TECHNICAL EVALUATION REPORT ON THE ADEQUACY OF  
ELECTRIC DISTRIBUTION SYSTEM VOLTAGES  
FOR THE POINT BEACH NUCLEAR PLANT  
UNITS 1 AND 2

(Docket Nos. 50-266, 50-301)

February 9, 1983

FIGURE 1 POINT BEACH NUCLEAR PLANTS UNITS 1 & 2 - ELECTRICAL ONE-LINE DIAGRAM

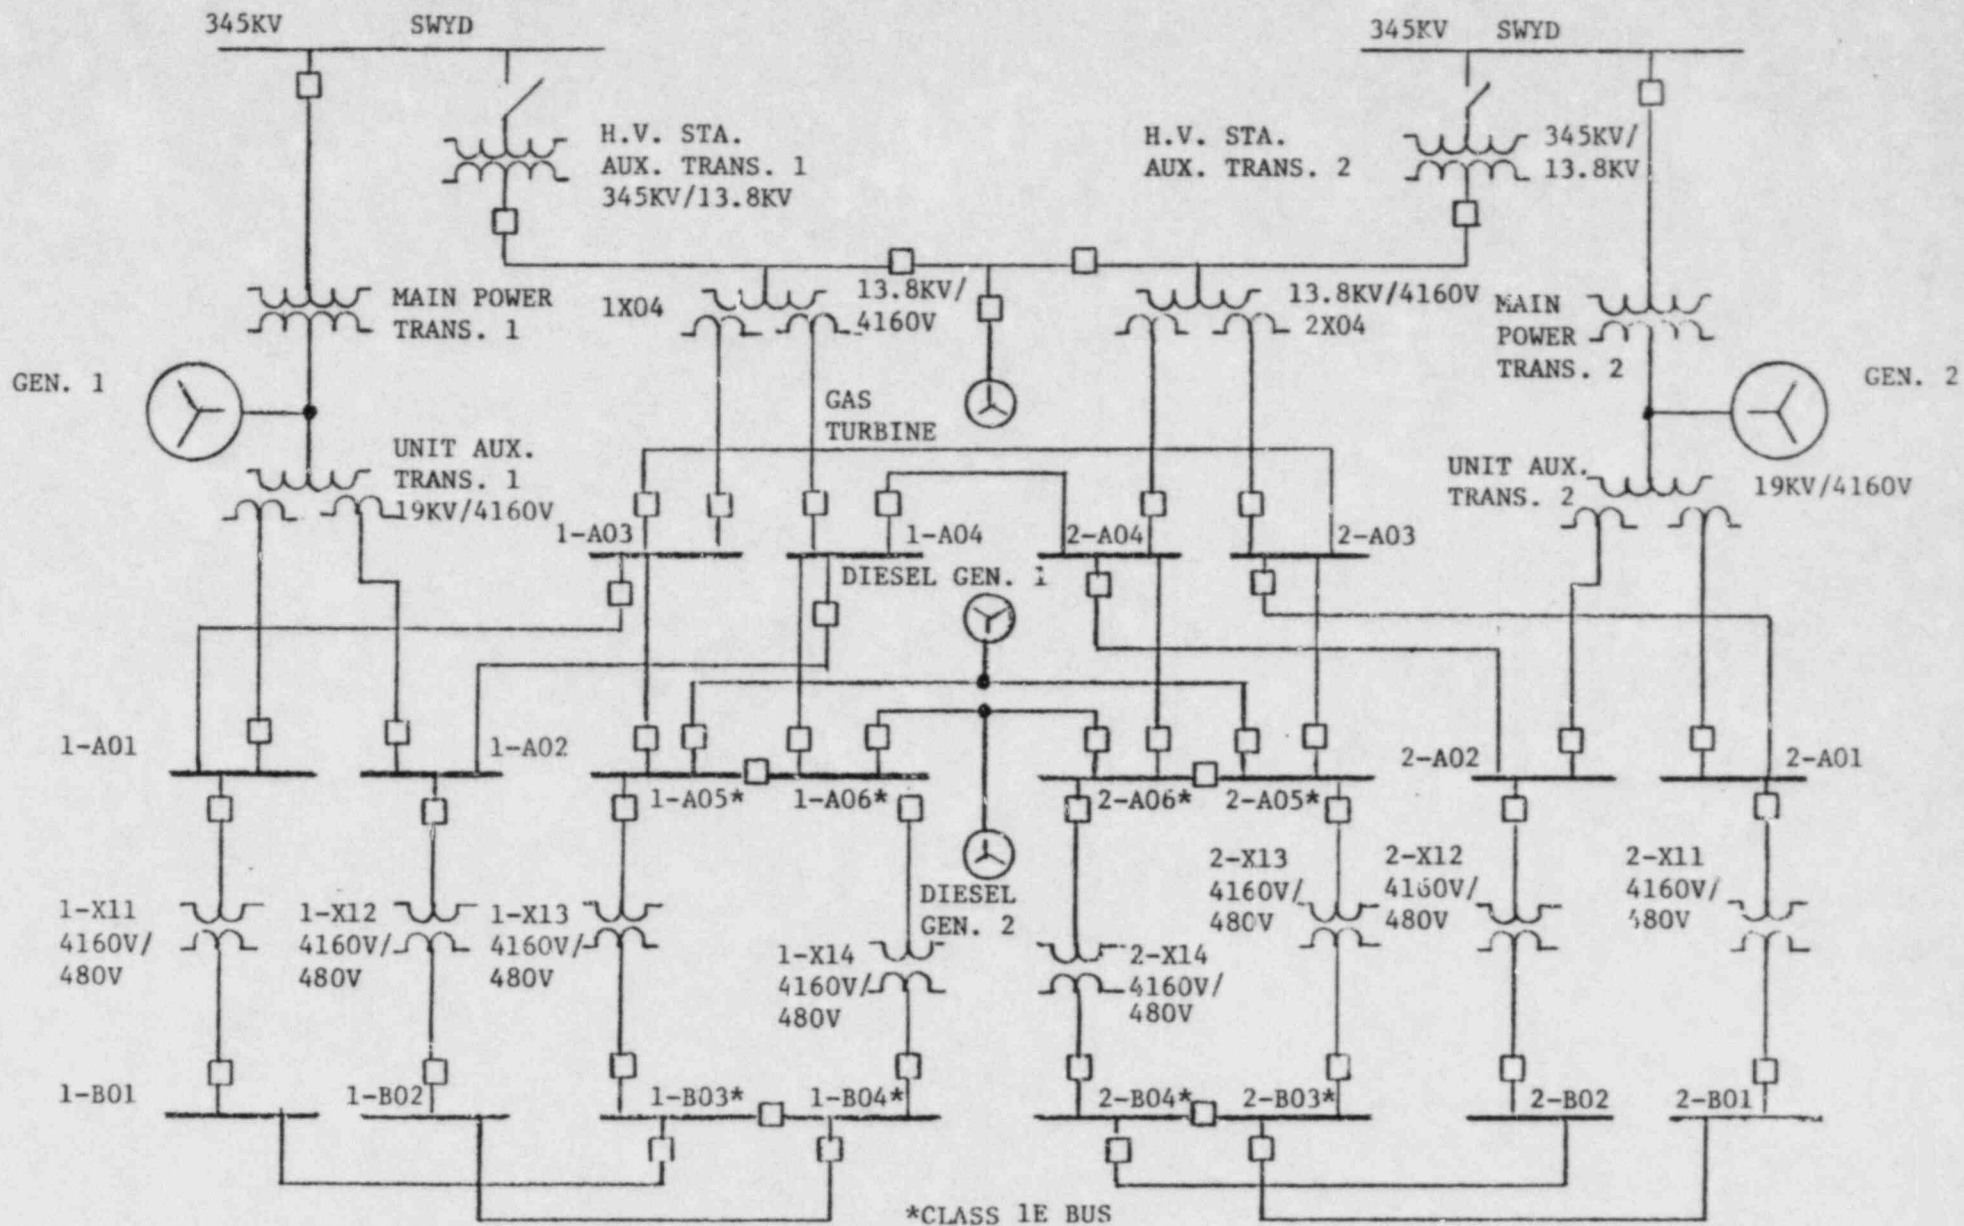
A one-line diagram of Point Beach Nuclear Plant's (PBNP) electrical distribution system is shown in Figure 1. This figure was adapted from Attachment 1 of Wisconsin Electric Power Company's (WEPCO) letter of January 21, 1981 [Ref. 3]. A 345 kV switchyard energizes two 345/13.8 kV high voltage auxiliary transformers. The high voltage auxiliary transformers energize two low voltage 13.8/4.160 kV transformers which in turn energize the 4160-volt Class 1E buses.

There are two 4160-volt Class 1E buses and two 480-volt Class 1E buses for each unit. The 4160-volt Class 1E buses A05 and A06 are energized by switching-buses A03 and A04 for each unit. A03 and A04 also energize non-Class 1E buses A01 and A02 during shutdown and startup. The Class 1E buses are not energized by the unit auxiliary transformer, but are energized from the

offsite source through the low voltage station auxiliary transformers. If the voltage on the 345 kV switchyard buses falls below 350 kV an alarm is initiated in the plant control room and at the system control center to alert the operators to attempt voltage adjustments. In the event of loss of offsite power or a degraded offsite voltage condition, the Class 1E buses are automatically transferred to the emergency diesel generators [Ref. 10]. In the event of a unit trip or plant shutdown, the non-Class 1E buses A01 and A02 are transferred to A03 and A04.

The licensee was requested to evaluate the proximity of the 1X04 and 2X04 transformers for the possibility of a fire or similar accident in one transformer having a detrimental effect on the other transformer. This issue is being investigated by the NRC Region 3 office.
